Job:
RESIDENTIAL FLAT
BUILDING: - 1147, 1149
PACIFIC HWY & 2 BOBBIN
HEAD ROAD PYMBLE

BASEMENT LEVEL 1

SK04A

CROSS VENTILATION DIAGRAM - THIRD FLOOR PLAN
SCALE 1:200 @ A0

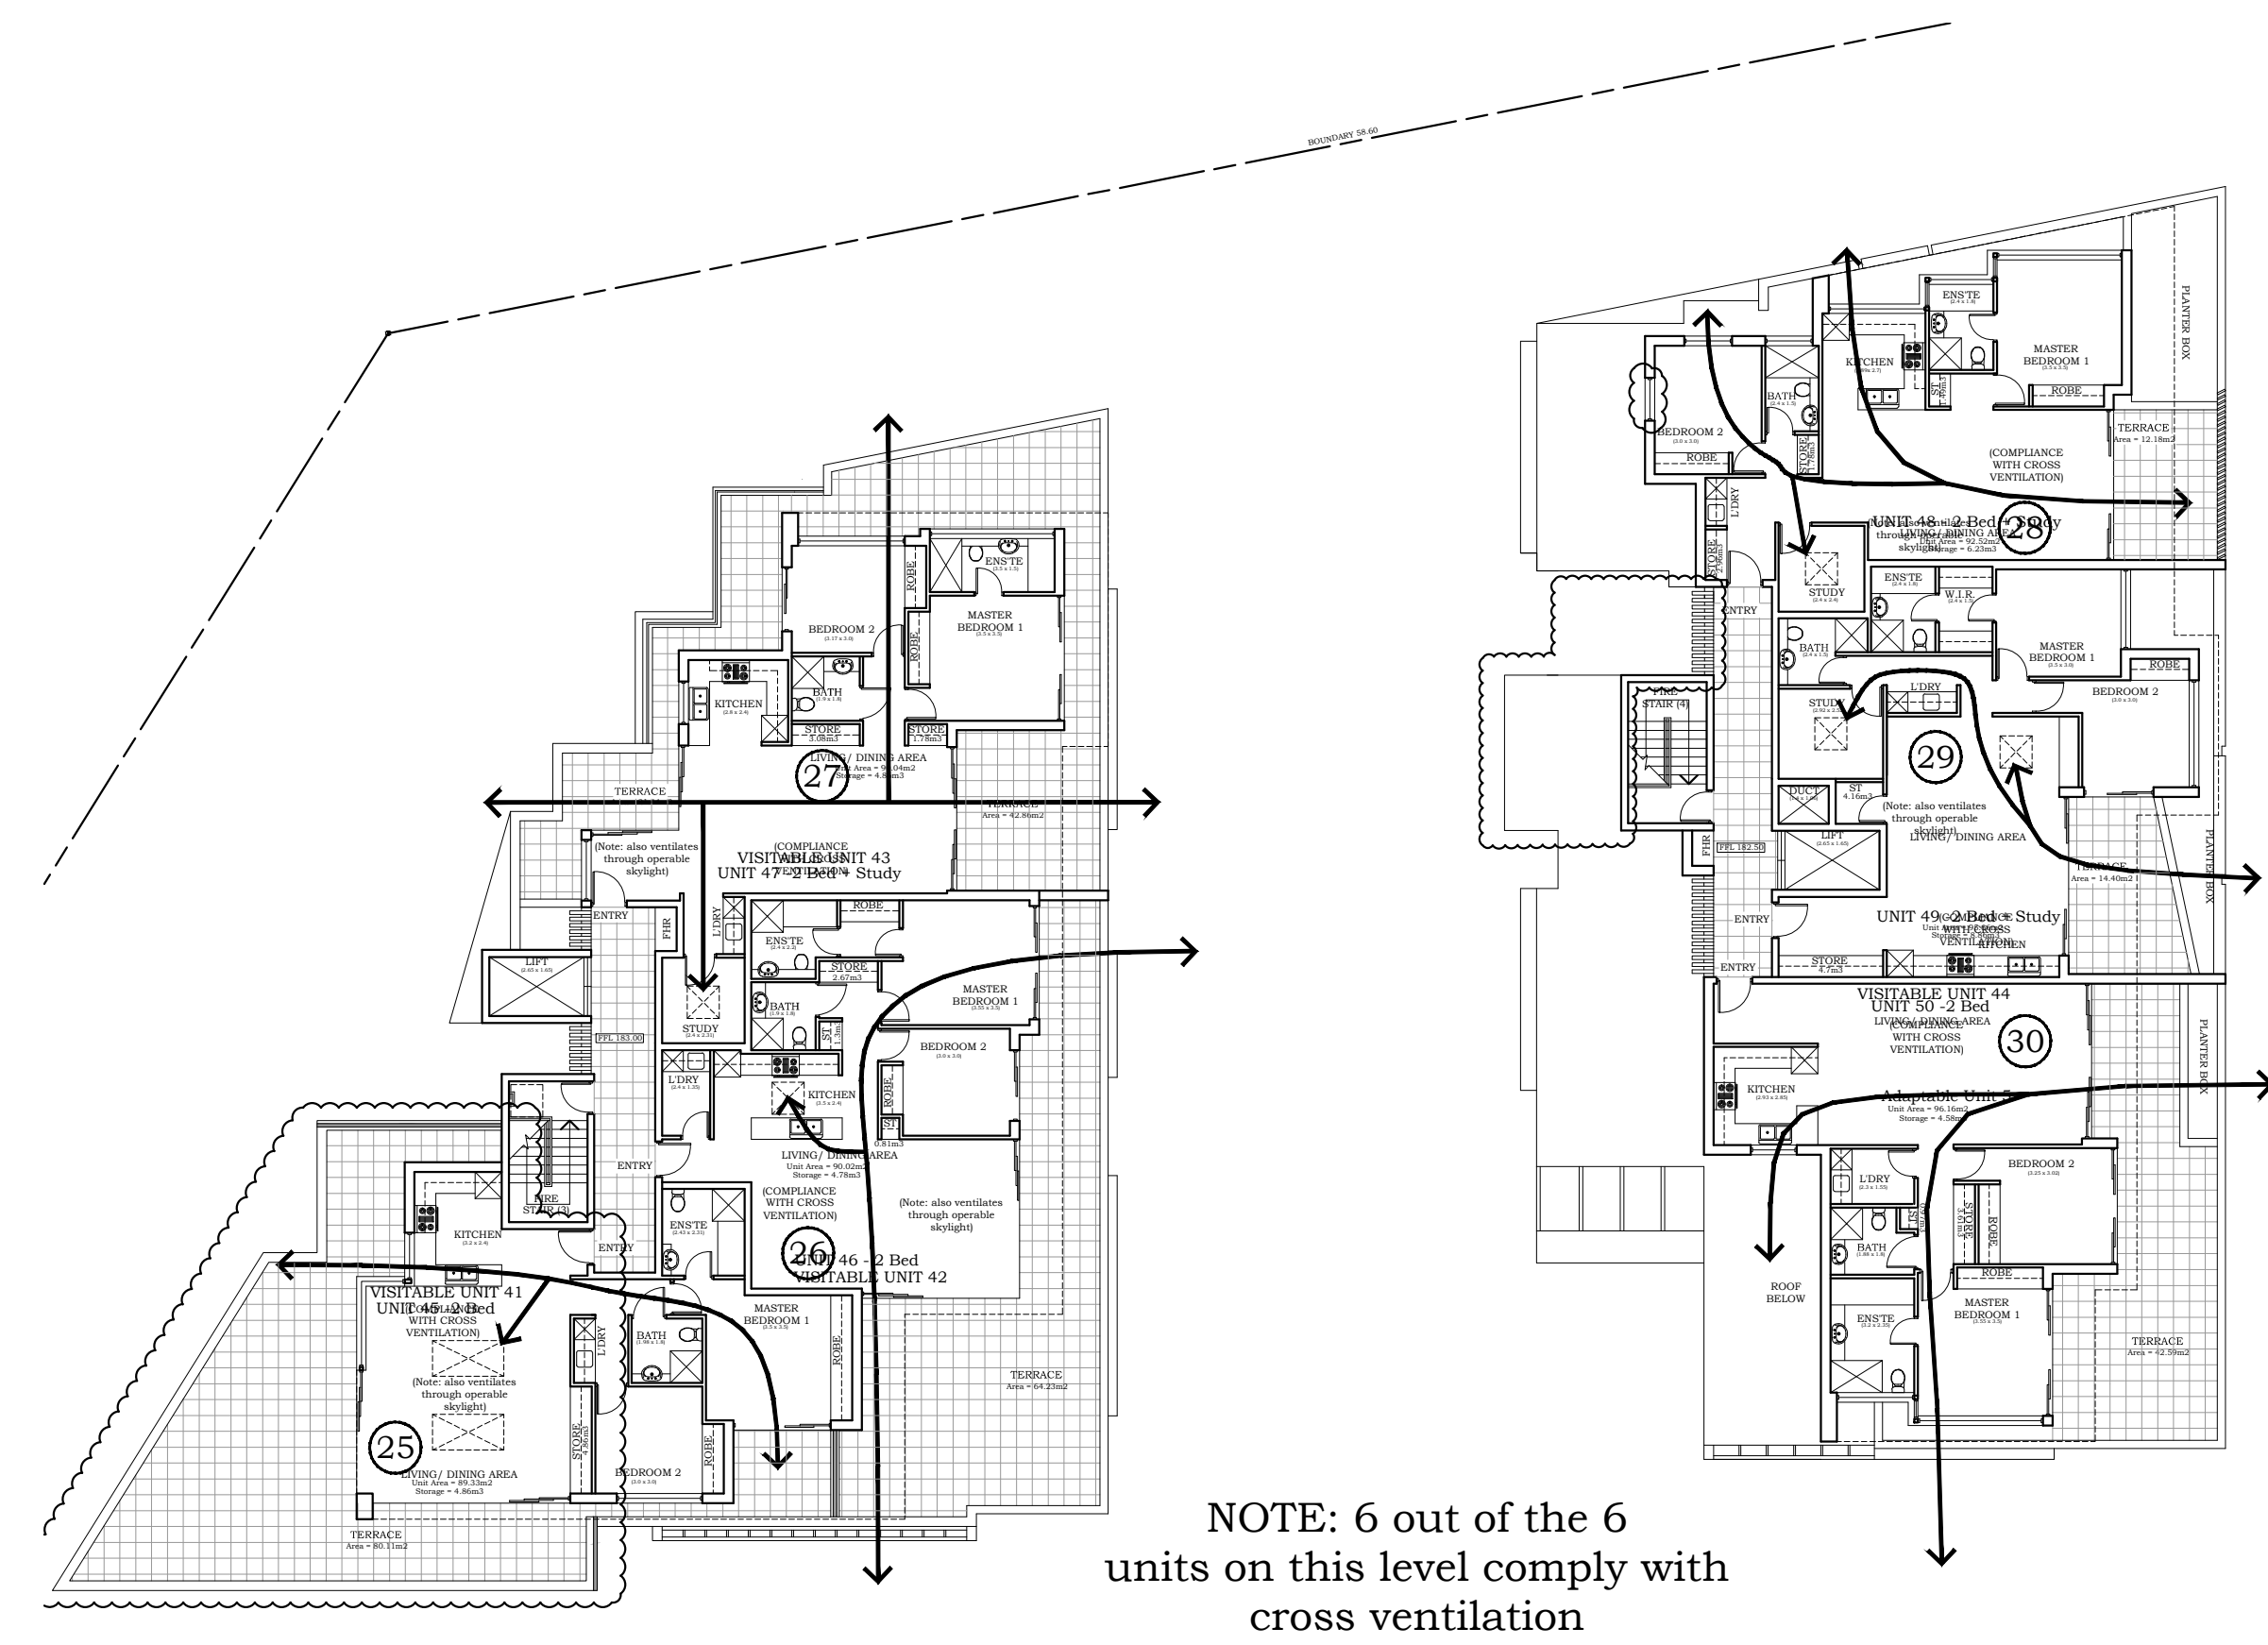
REV	AMENDMENTS	DATE
A	<ul style="list-style-type: none">- the private courtyards adjacent to the northern boundary have been setback further from the northern boundary.- egress path has been added adjacent to fire stair 3- egress path has been amended adjacent to fire stair 2 & 4 so that more doors & windows are 6m away from the egress path- pedestrian path/ramp adjacent to disabled entry now complies with the Australian standards- substation has been moved so that it now lines up with the street frontage.- Courtyard of unit 11 has increased in size.- Paving has been added to the courtyards of unit 7 & 11.- Stepping stones have been removed from the private courtyard of unit 1	30.05.11

Job:
**RESIDENTIAL FLAT
BUILDING: - 1147, 1149
PACIFIC HWY & 2 BOBBIN
HEAD ROAD PYMBLE**
Drawing title:
**PROPOSED SHADOW
DIAGRAMS - 9AM, 3PM
& 12 NOON JUNE 22ND**
North point:

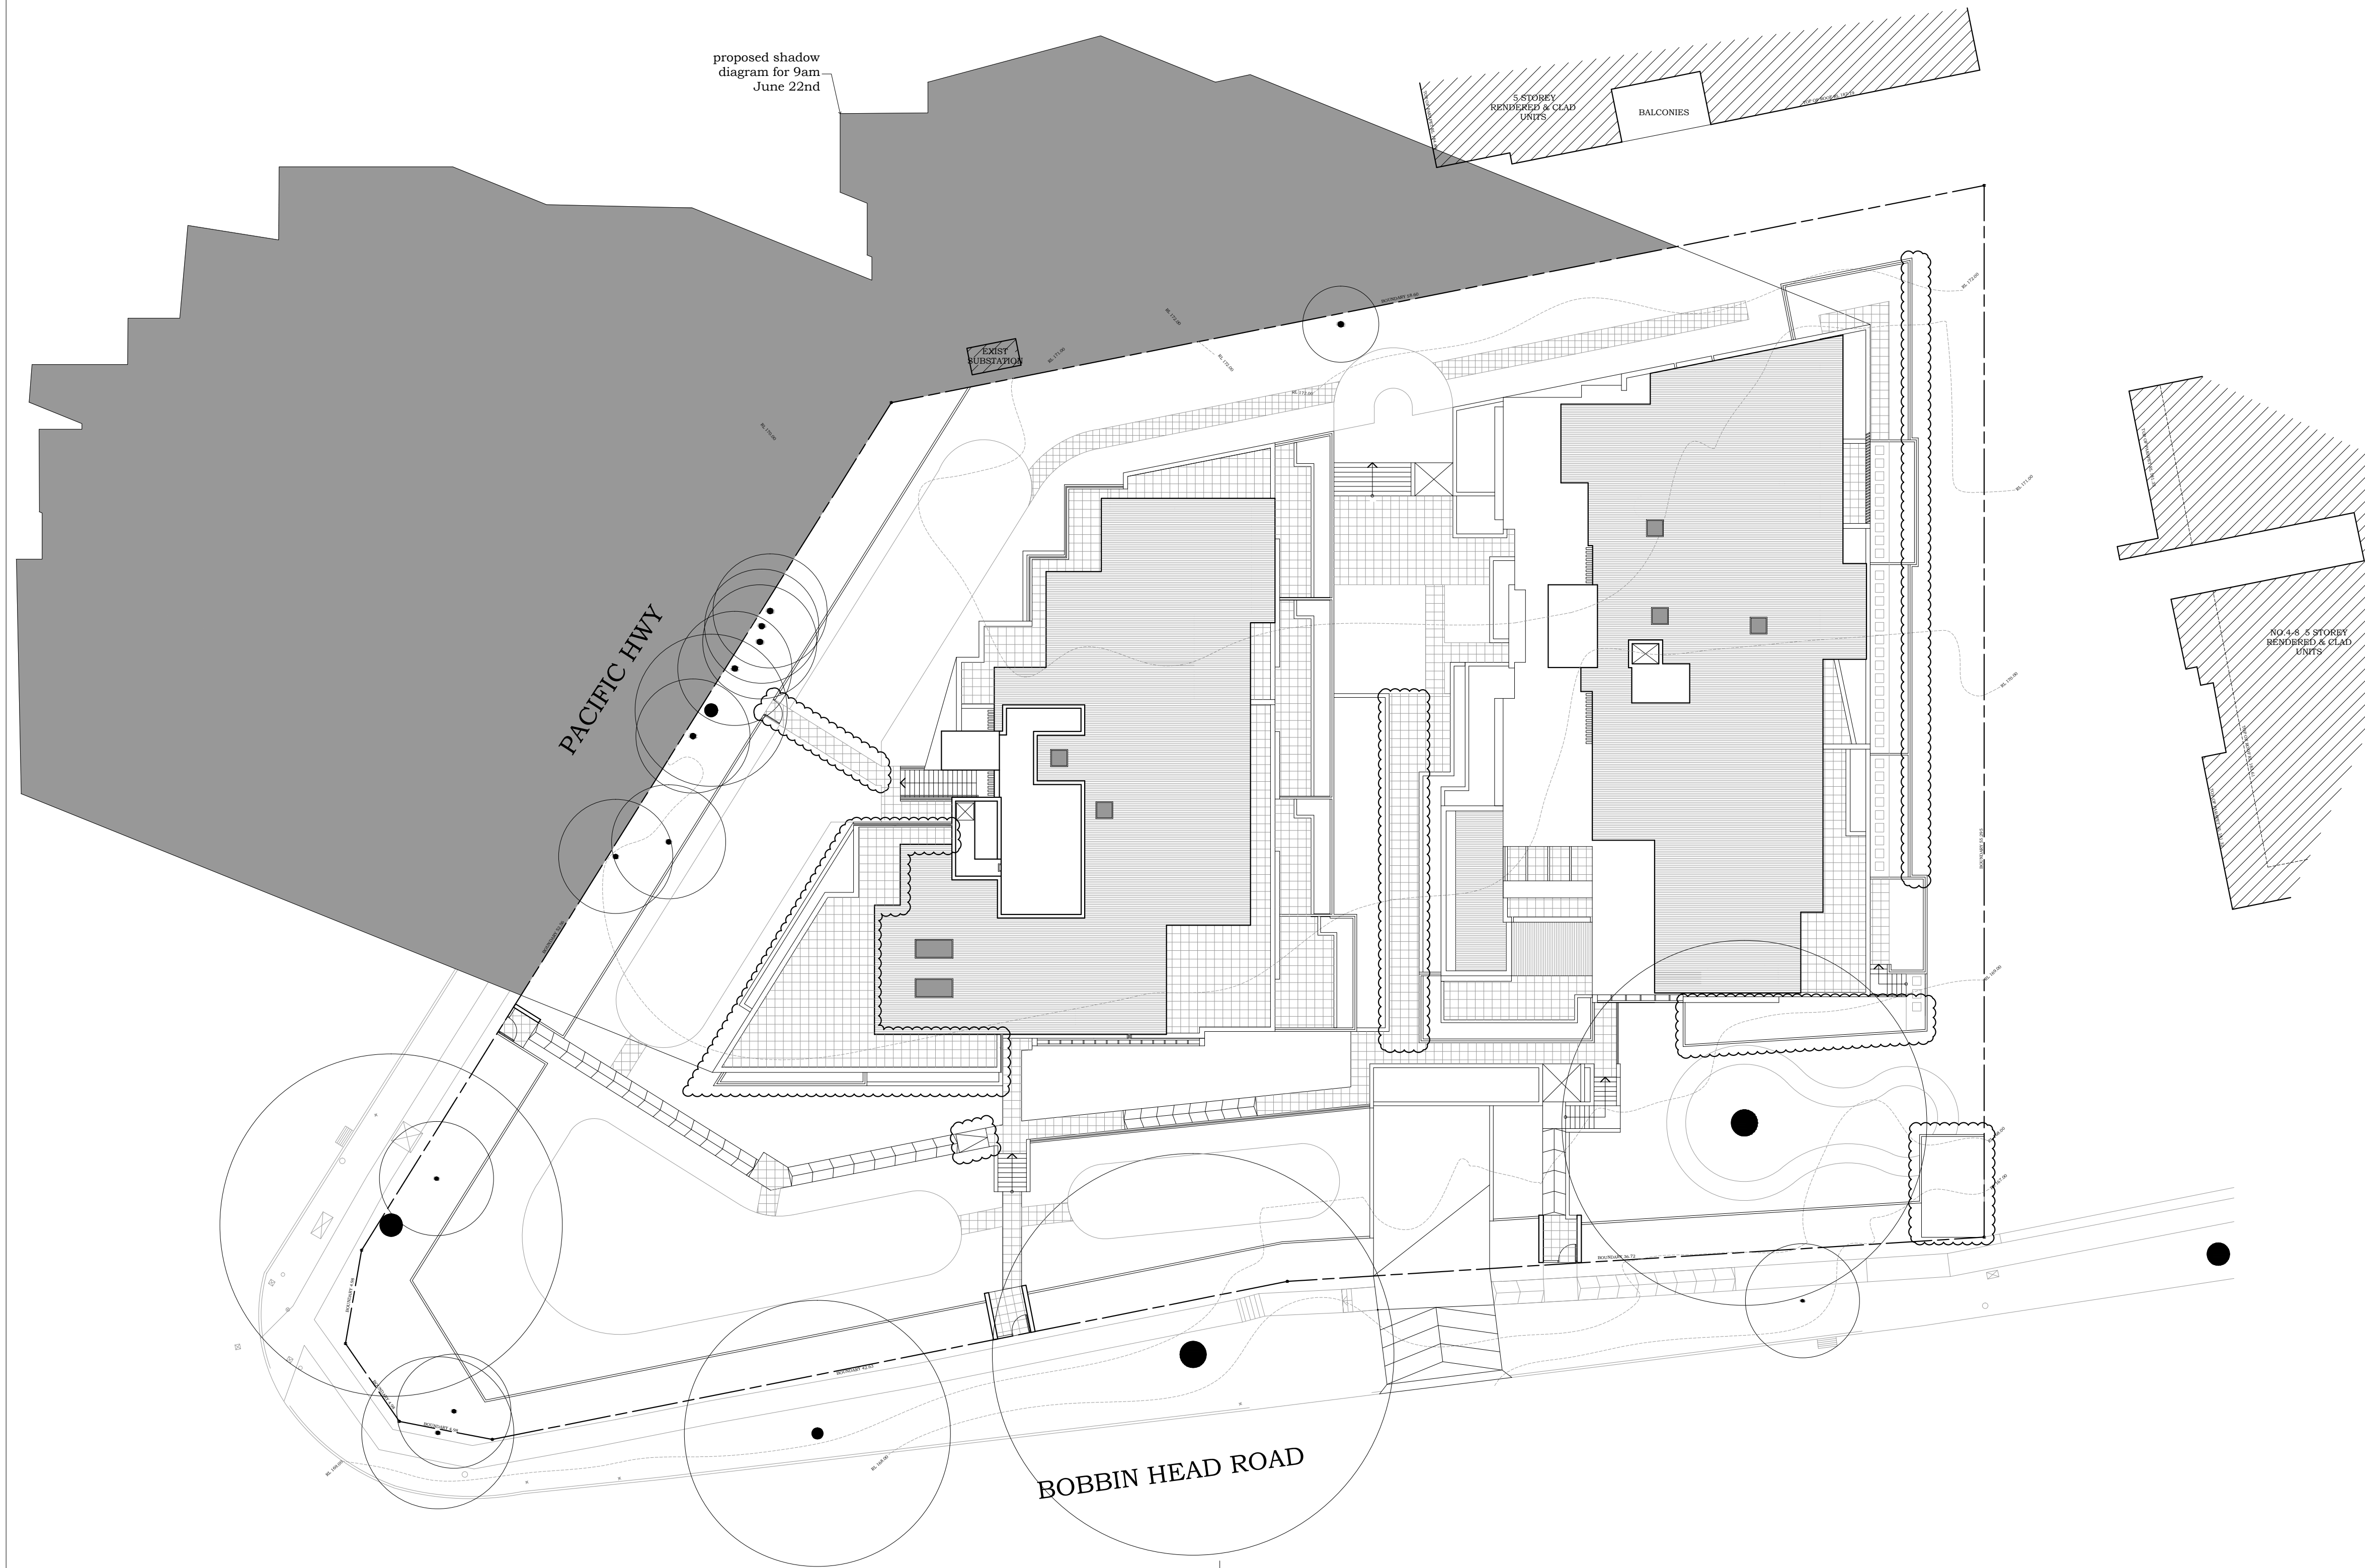
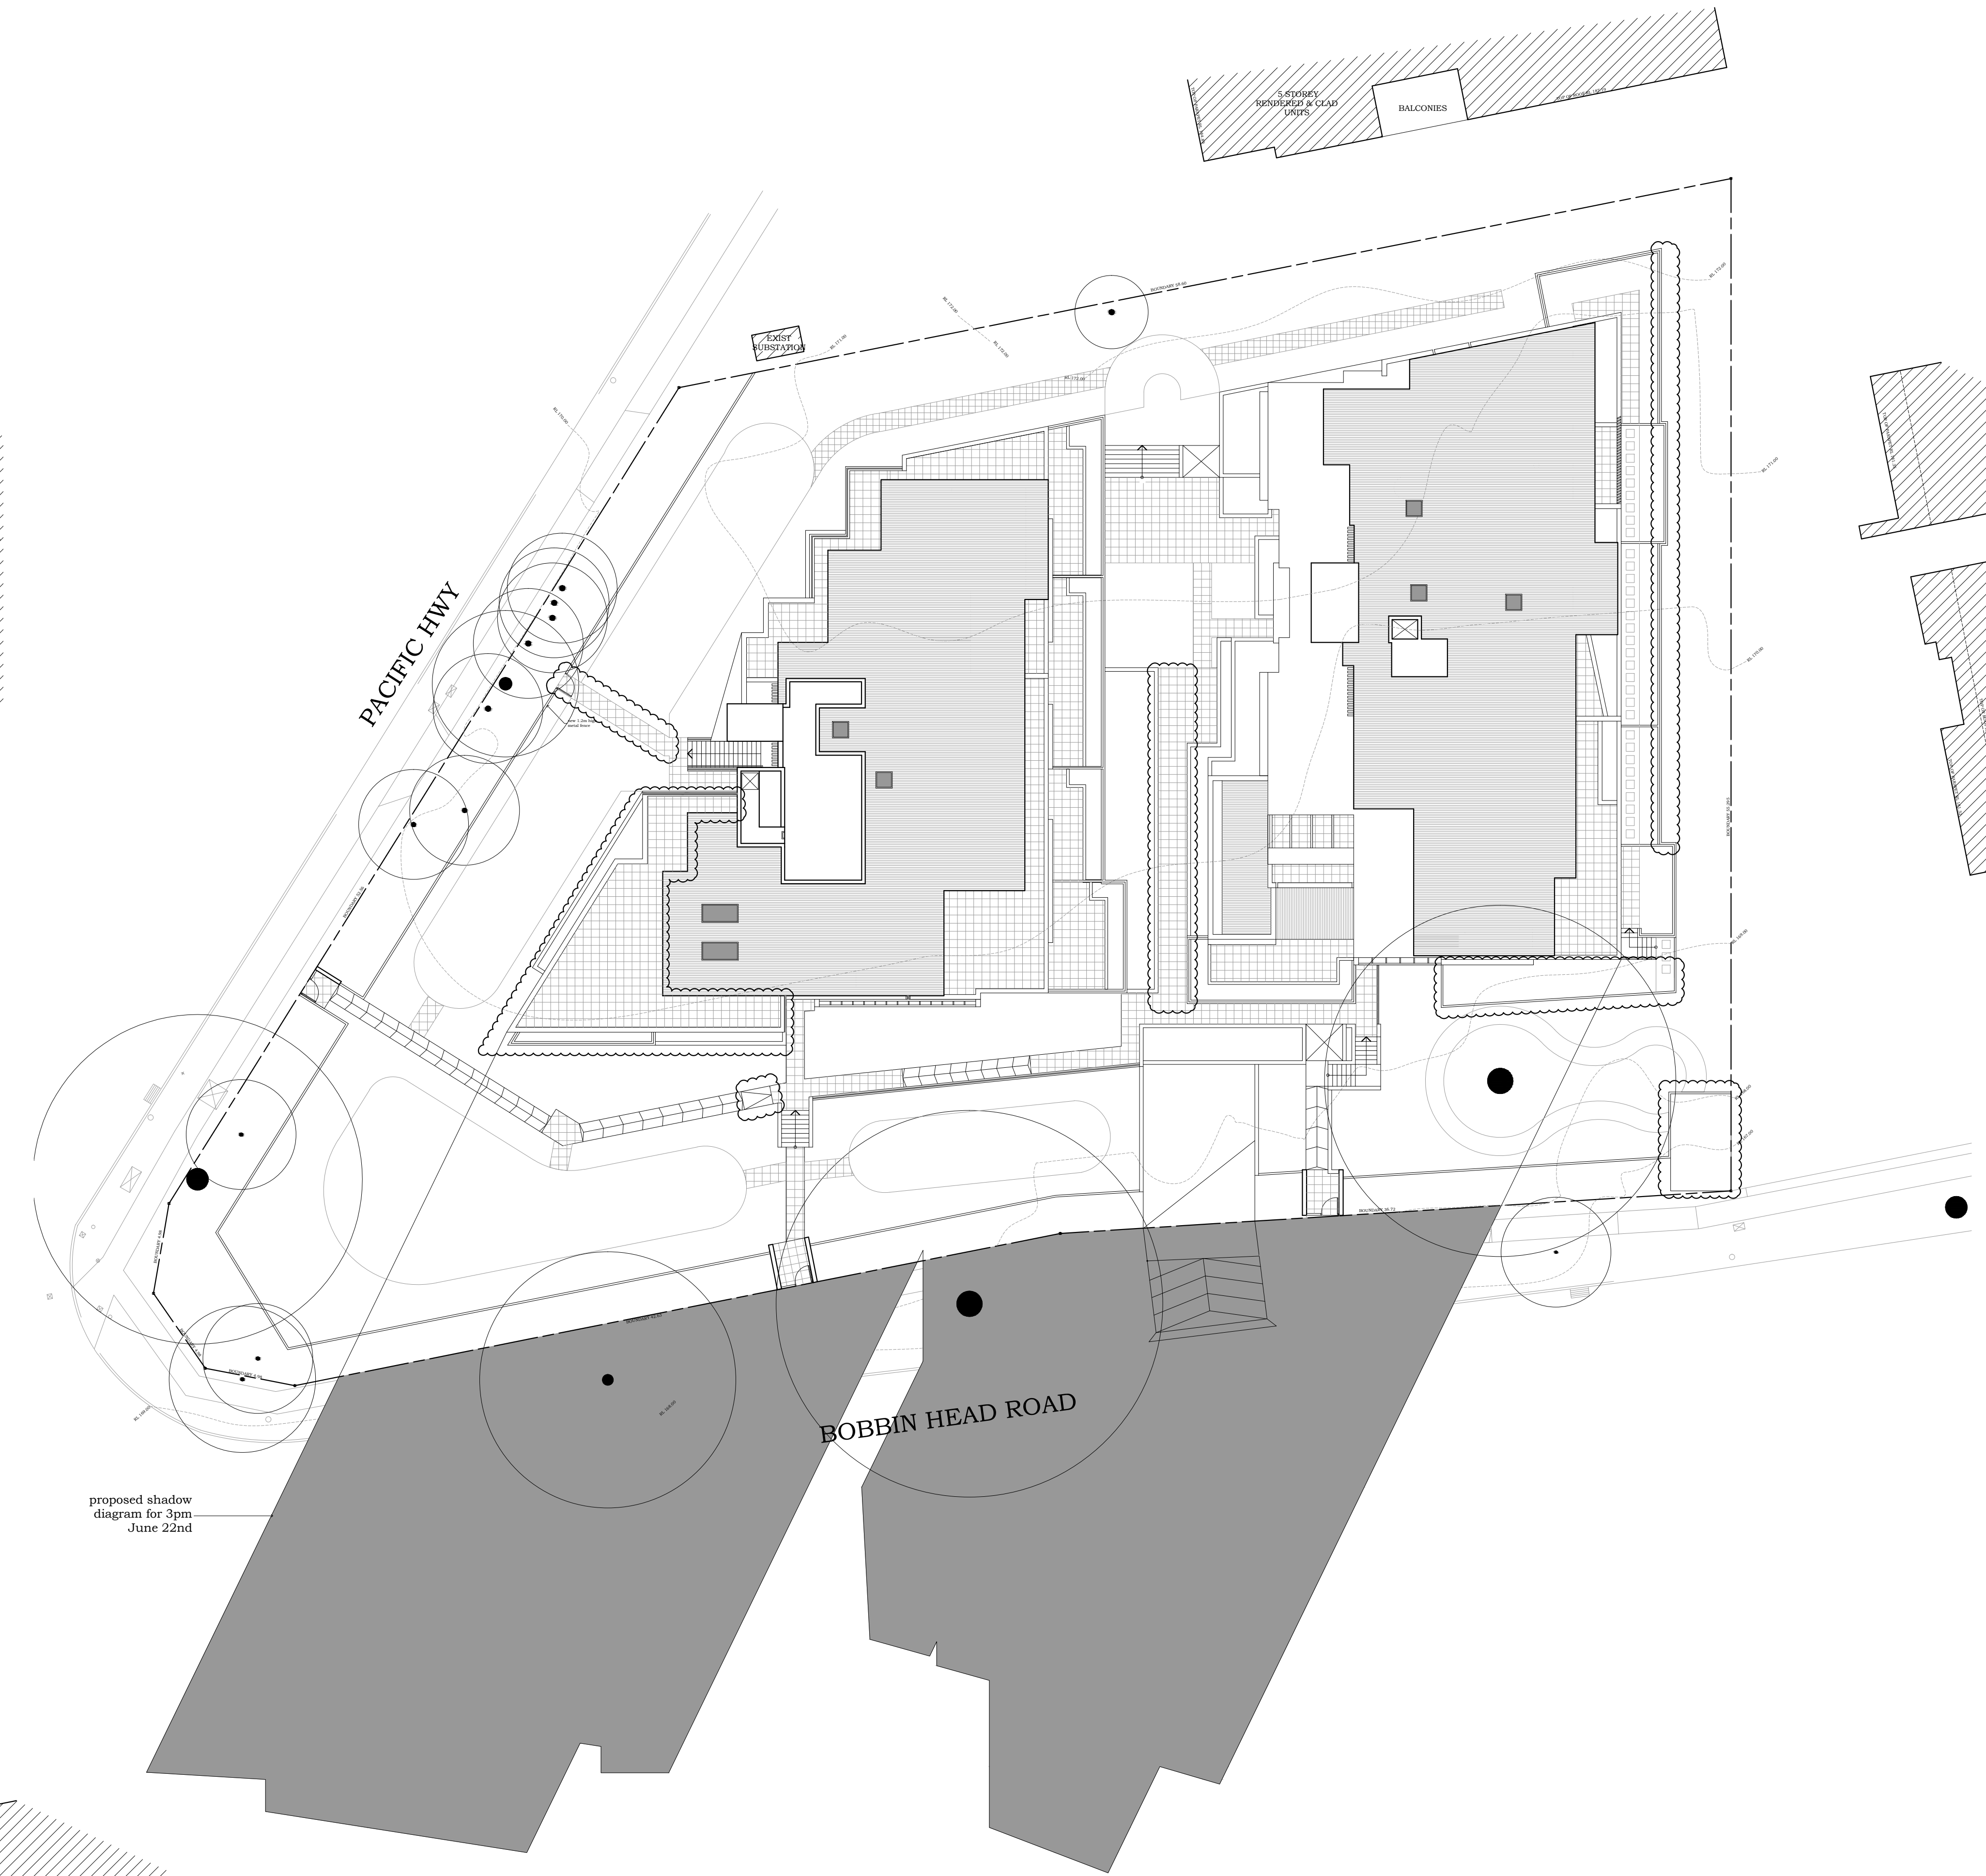
REV	AMENDMENTS	DATE
A	<ul style="list-style-type: none">- the private courtyards adjacent to the northern boundary have been setback further from the northern boundary.- egress path has been added adjacent to fire stair 3- egress path has been amended adjacent to fire stair 2 & 4 so that more doors & windows are 6m away from the egress path- pedestrian path/ramp adjacent to disabled entry now complies with the Australian startdards- substation has been moved so that it now lines up with the street frontage.- Courtyard of unit 11 has increased in size.- Paving has been added to the courtyards of unit 7 & 11.- Stepping stones have been removed from the private courtyard of unit 1	30.05.11
